**ASSESSMENT REPORT – COMMERCIAL DEVELOPMENT
S79C – Environmental Planning & Assessment Act 1979**

DA No:	DA/455/2011
Assessment Officer:	Kate Lafferty
Property:	40-70 Church Street, Parramatta Lot 1 DP734700 & Lot 2 DP734955, Lot 3 DP827013, Lot 1 DP1025899
Proposal:	Demolition and construction of a 4 storey motor showroom over a basement service centre
Cost of works:	\$33,607,046
Date of receipt:	4 July 2011
Applicant:	Manson Group
Owner:	TC Properties Pty Ltd & Parramatta 101 Pty Limited
Submissions received:	No submissions received
Property owned by a Council employee or Councillor:	No
Council application:	No
Issues:	Flooding
Recommendation:	Approval subject to conditions
Determination:	The development will be determined by the Western Sydney Joint Regional Planning Panel as the cost of development exceeded \$10 million at the time of lodgement on 4 July 2011

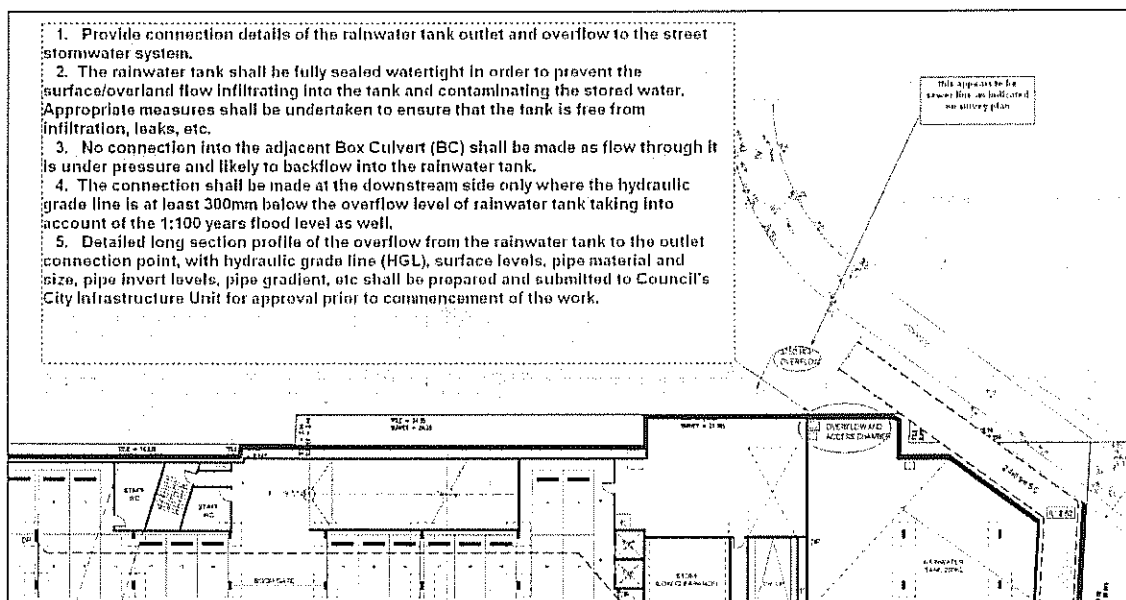
The proposed stormwater management plan consists of two On-Site Detention (OSD) systems, one on the roof top with the storage on the roof top (Level 3) car park covering the whole roof area and another one on the second floor (Level 2) car park covering the open space (exposed area) of the car park and storage on car park. The outflow from the OSD system is proposed to be discharged into 200KL rainwater tank at the ground floor which will overflow into the proposed new drainage system (box culvert) along the southern property boundary.

The stormwater plan/proposal was assessed for its acceptability by Council. The stormwater proposal had a few issues which were communicated to the applicant. Following this, an amended stormwater plan was submitted. However, the amended plan still has a few issues. The relevant issues are marked on the stormwater plan together with comments, notes and rectification requirements which need to be addressed. In general the OSD proposal appears to be satisfactory with minor issues which are marked on the plan with the rectification requirements.

One of the main issues of the proposal is the location of the rainwater tank which is under the overland flow path. The connection from the rainwater tank to the

The stormwater plan has issues and is not acceptable as such. However, if the plans are rectified addressing all the issues and incorporating all the notes, comments and rectification recruitments as marked on the plans, and then the rectified plans, then the plans can be made acceptable in terms of OSD proposal. If this DA proposal is to be approved the following conditions should be imposed:

- i) rectification of the stormwater plan, incorporating all issues, notes and comments marked on the approved revised stormwater plan prior to lodgement of application for the Construction Certificate, and*
- ii) imposition of the conditions listed below:*
